DTB

Date: April 10, 2007
Order No.: T-B-41.10/03a
Supersedes: T-B-41.10/03 dated Nov. 17, 2005
Group: 41

SUBJECT: Model 164.175/186
Up to June 30, 2005 Production Date, VIN Range A000826 to A026114
Vibration at Front Driveshaft While Driving at Highway Speeds

Figure 1

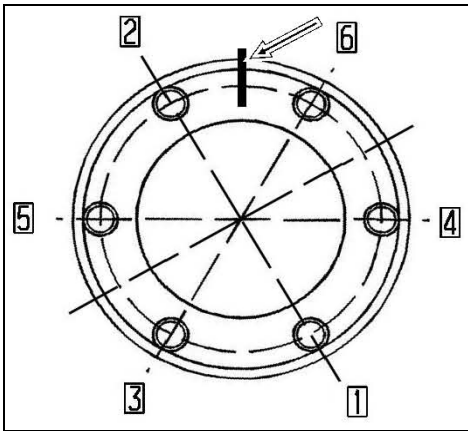
1. Replace bolts on the constant velocity joint between the front differential and the front driveshaft, observe the following tightening instructions (Figure 1).
2. White markings on front axle gear propeller shaft constant velocity joint and on front axle gear flange must be at the 12 o' clock position (Figure 2, arrow), until bolt 1 (Figure 1) has been tightened with initial torque. Always observe the tightening pattern.
 - a. Tighten bolt 1 (Figure 1) with 10 Nm initial torque.
 - b. Tighten the opposite bolt 2 to 40 Nm+ 90° tightening angle by turning propeller shaft through 180°. Then tighten bolts 3 - 4 - 1 - 5 - 6 to 40 Nm+ 90° tightening angle by turning propeller shaft accordingly (mark tightened bolts to give a better overview).
